## **Service Bulletin**

**Date: Mar-2016**

**Product: Dual Stage Snow Throwers, 200 series only**

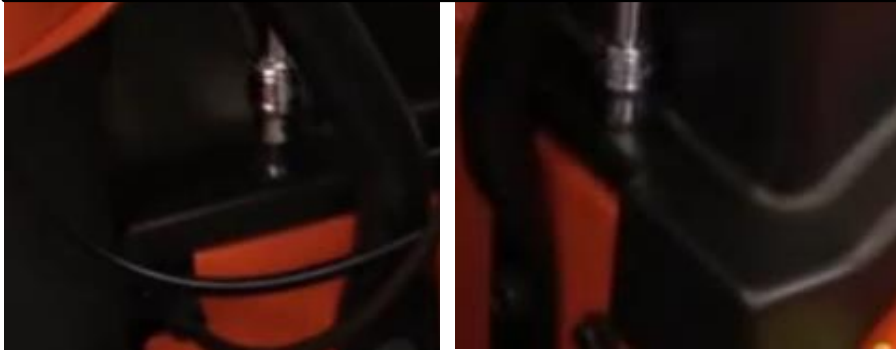
3. Remove engine pulley bolt and install new bolt. Also install washer if specified on page 2. Torque 40-55 ft-lbs to tighten bolt.

Old engine pulley bolt part number: 532179617  
**New engine pulley bolt part number: 532191760\***

**\*Model ST 76EP (961910060) will also require washer 532851074 (see page 2).**
